**THE METROPOLITAN DISTRICT  
HARTFORD, CONNECTICUT**

**SPECIAL DEVELOPMENT DISTRICT AND ZONE  
CHANGE REQUEST FOR SOUTH TUNNEL ACCESS  
SHAFT AT 1 CHARTER OAK BOULEVARD IN  
TOWN OF WEST HARTFORD**

Re: Special Development District and Zone Change Request Application #144  
Metropolitan District Commission (MDC) in conjunction with the South Hartford  
Conveyance and Storage Tunnel Project.  
**Supplemental Project Information and Request**

DOCUMENT REVIEW COMMENTS			
Job No.: <b>60287608</b>	Title: <b>West Hartford Zone Change/SDD Request</b>	Date: <b>7/16/15</b>	
Preparer: <b>James Sullivan</b>	Reviewer: <b>Town of West Hartford</b>	Responder: <b>Various/Below</b>	
Discipline: <b>MDC South Tunnel - All</b>	Status:	<input type="checkbox"/> Criteria <input type="checkbox"/> 100% <input type="checkbox"/> 90%	<input type="checkbox"/> 60% <input type="checkbox"/> 30% <input checked="" type="checkbox"/> <b>SDD and Zone Change Application</b>
REVIEW PURPOSE:	<input type="checkbox"/> Independent Peer Review <input type="checkbox"/> Discipline <input type="checkbox"/> Project Approach Review	<input type="checkbox"/> Interdiscipline <input checked="" type="checkbox"/> Other	Action Code:

**230 C-131**

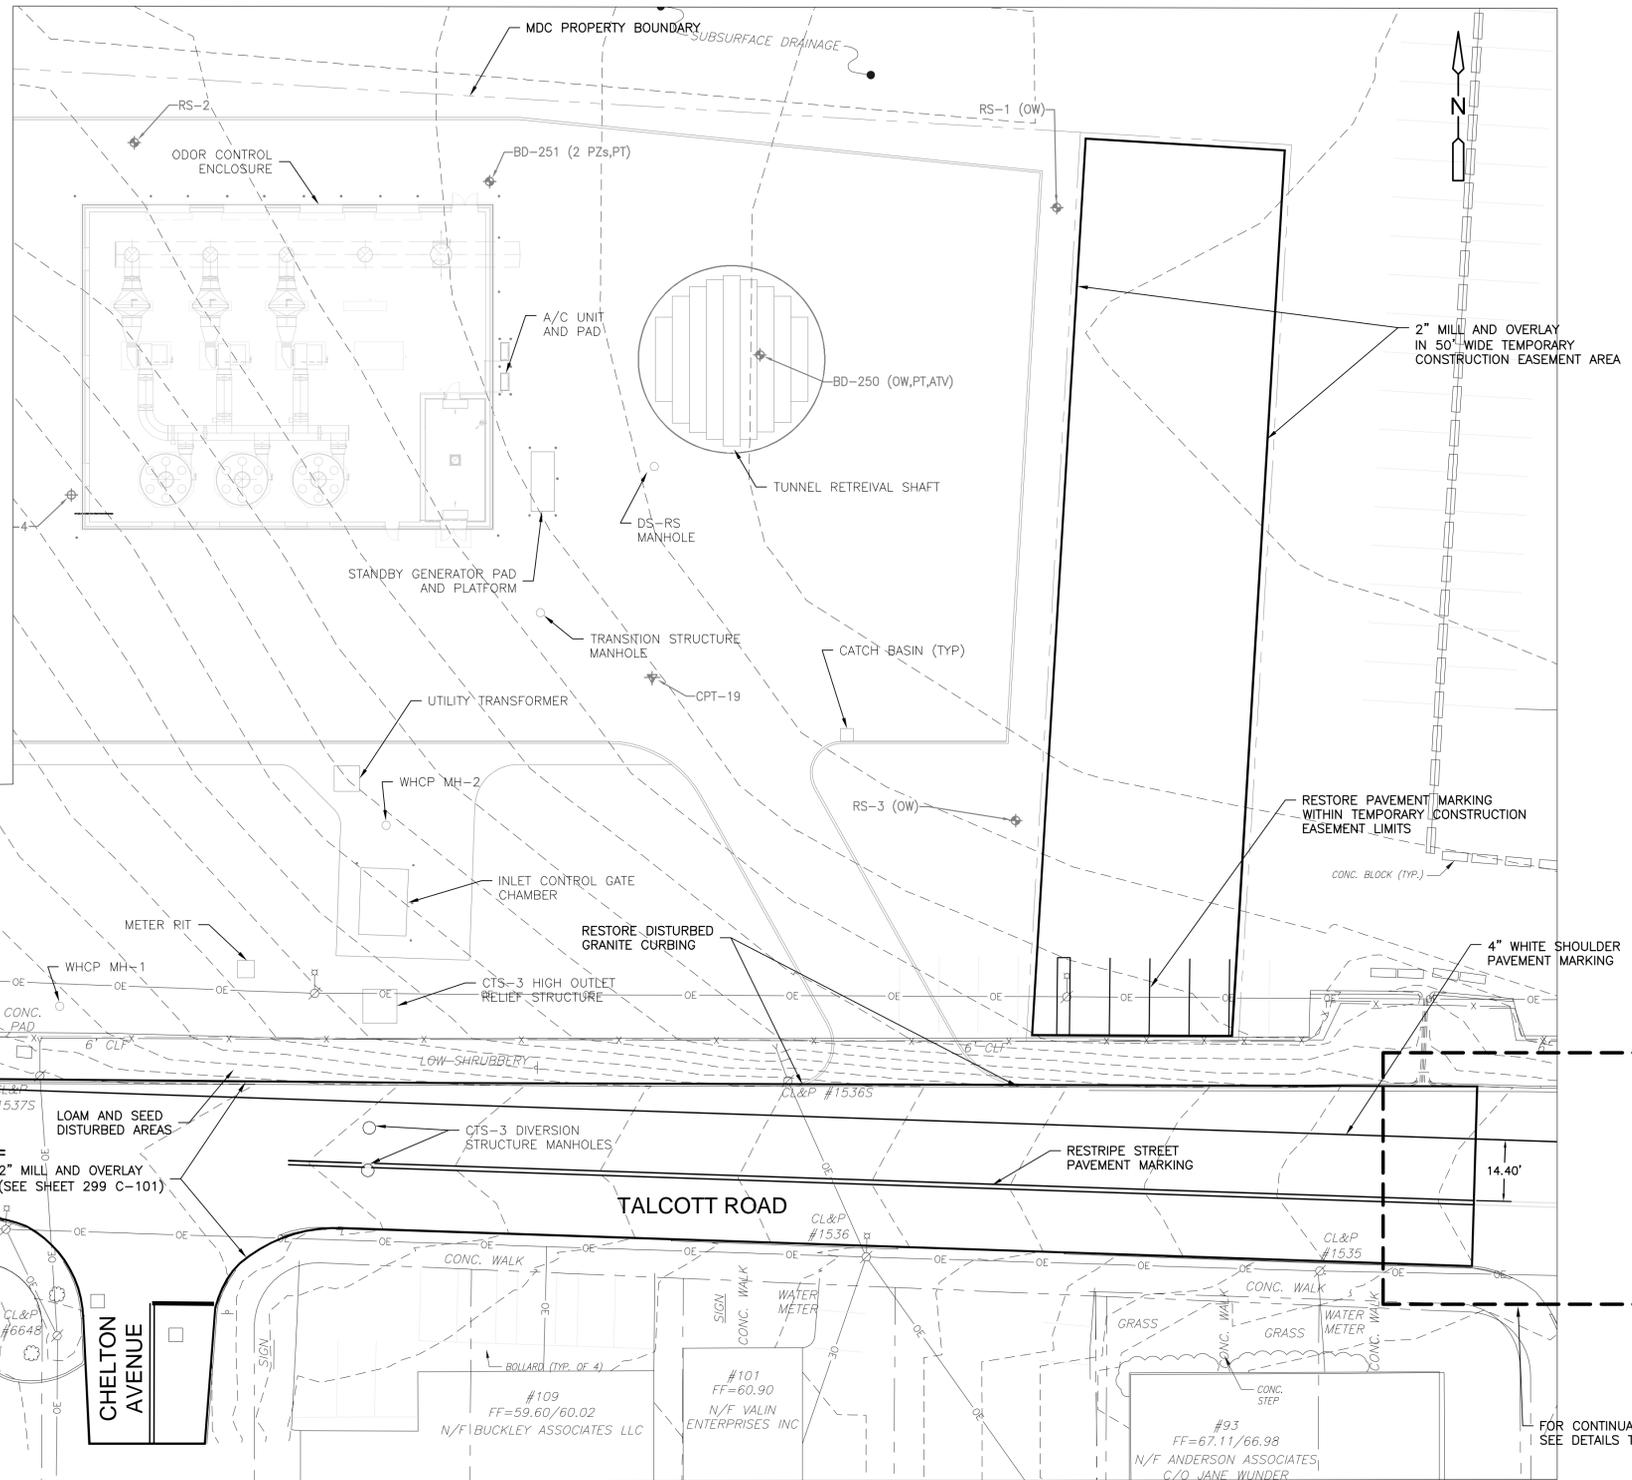
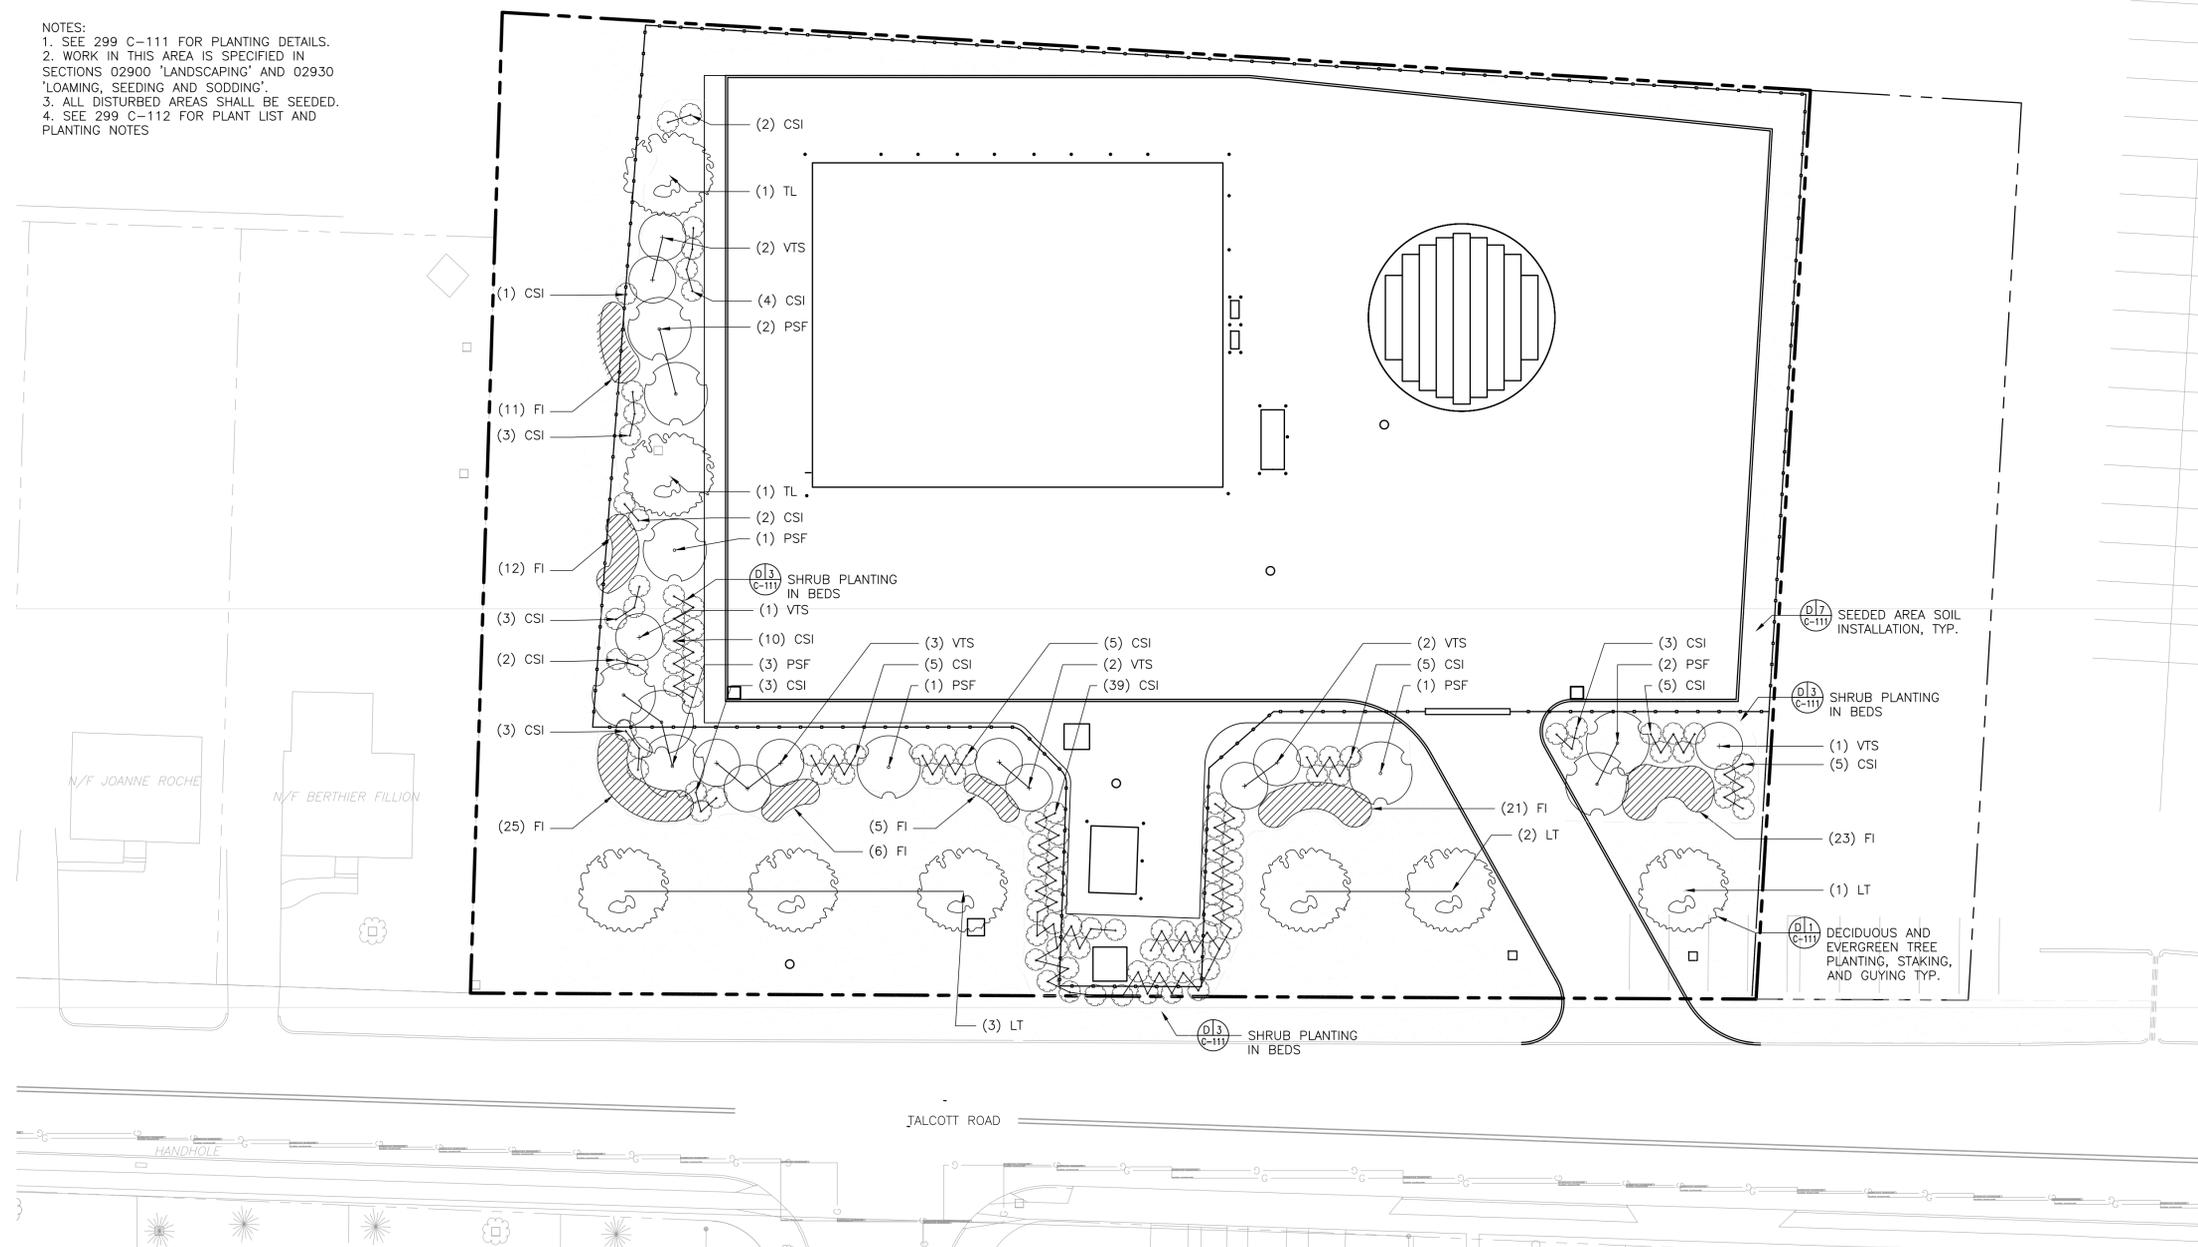
E-6	What are the limits of the Talcott Road pavement restoration and what type of restoration is proposed?	An updated mill and overlay restoration sheet and full depth pavement details are provided in the modified plan set (Enclosure F).
E-7	The Talcott Road pavement cross section is 3" Class 1 asphalt (2 - 1 %" lifts) on 4" Class 4 asphalt on 12" processed aggregate base. Any road restoration shall match this thickness and material.	The full depth pavement restoration detail has been updated to account for the existing pavement section in Talcott Rd. The contractor is required to provide full depth pavement restoration 1 foot outside the actual excavation limits as shown in the modified plan set (Enclosure F).
E-8	Abbreviation Legend has not been included in plan set.	This has been included to the modified plan set (Enclosure F).
E-9	Show callouts for existing structures including top of frame and inverts.	Additional sheets showing this information have been added to the modified plan set (Enclosure F).

REV. NO.	DATE	DRWN	CHKD	REMARKS
1	7/16/15	SG	JS	REVISED PAVEMENT MARKING AND MILL AND OVERLAY LIMITS
